UNITED STATES PATENT AND TRADEMARK OFFICE

APPLICATION NO.	FILING DATE	FIRST NAMED INVENTOR	ATTORNEY DOCKET NO.	CONFIRMATION NO.
10/016,132	12/17/2001	Ali Rusta-Sallehy	9351-87 HSF	4158
1059	7590	11/17/2004		
BERESKIN AND PARR SCOTIA PLAZA 40 KING STREET WEST-SUITE 4000 BOX 401 TORONTO, ON M5H 3Y2 CANADA			EXAMINER RIDLEY, BASIA ANNA	
			ART UNIT 1764	PAPER NUMBER

Office Action Summary

DETAILED ACTION

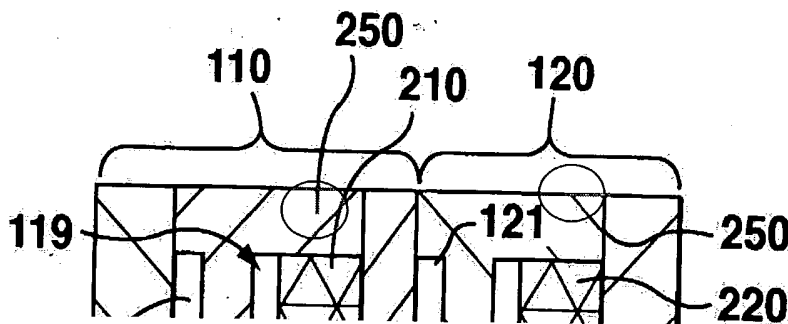
3. The Replacement Figures 6 and 8 were received on 13 August 2004. These drawings are acceptable.
4. The drawings filed on 11 March 2002 are objected to as failing to comply with 37 CFR 1.84(p)(4) because reference character "250" in Fig. 1a has been used to designate, both, a rim and an external wall of reactor stack. See below reproduced cutout of Fig. 1a with added markings to clarify the objection:

Corrected drawing sheets in compliance with 37 CFR 1.121(d) are required in reply to the
